From: Oliver Benson <Oliver.Benson@midsussex.gov.uk>
Sent: 19 May 2025 12:00:01 UTC+01:00
To: "Joanne Fisher" <Joanne.Fisher@midsussex.gov.uk>
Subject: RE: DM/25/0898 - SHELL BURGESS HILL, SERVICE STATION, 173 LONDON ROAD, BURGESS HILL

Subject: DM/25/0898 - SHELL BURGESS HILL, SERVICE STATION, 173 LONDON ROAD, BURGESS HILL

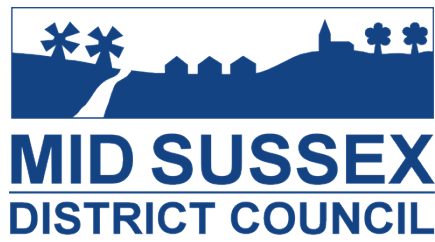
I have reviewed the new plan you have sent through for the extract that will vent through the wall.

I note it seems to only show an ON 100 Odour Control Unit in terms of mitigation.

The previous documentation seems to suggest that an additional control would be needed prior to this, such as an ESP particulate control unit.

Is a prior control being installed, and if so what, and if not, has it been confirmed that the current suggested control will be sufficient.

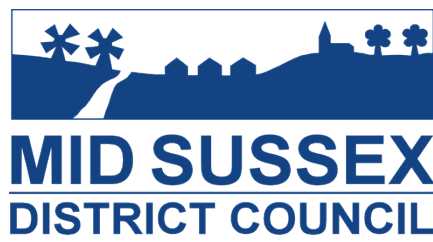
I have reviewed the information submitted from purified air, which has risk rated the potential impact from odour from the Prett kitchen as low to medium.

On this basis, it appears they recommend that there are several possible systems they could install, most likely as an ESP particulate control unit followed by ON 100 Odour Control Unit.

It would be good to clarify exactly what odour control will be put in place, before we discharge the odour condition.

Also, the applicant should ensure the ventilation system does not cause a noise issue.
